Re: DA 15-291 - 80 Tourle St Mayfield - clarifications

I am writing to you on behalf of Benedict Industries Pty Ltd regarding the proposed Mayfield West Recycling Facility (DA 15-291) (the proposal).

**Proposed site layout** Benedict Recycling Facility, Mayfield West

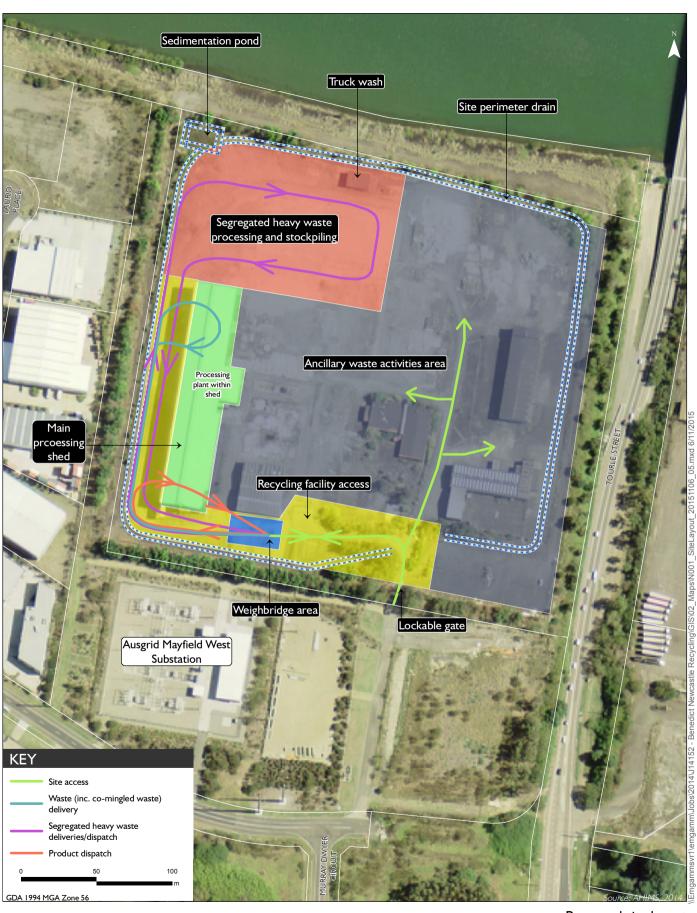
The easement over Lot 16 DP 270249 will be used to access the site. There is an existing road within the property that is suitable for accessing the proposal. No works are required, or are proposed, in Lot 16 DP270249 as part of DA 15-291. A site layout is attached that clarifies that the lockable gate at the southern end of the road in Lot 16 DP 270249 is not part of the site. This should be used in place of Figure 2.1 in the main EIS report.

The existing lockable gate at the southern end of the road in Lot 16 DP 270249 is described in the text (EIS Section 2.2.6). Installation of a new gate at this location is not part of DA 15-291. If this gate was to be removed by the landowner (Ausgrid), access to the site will still be restricted by the existing gate on the site. As such, there would be no changes to the impacts described in the EIS.
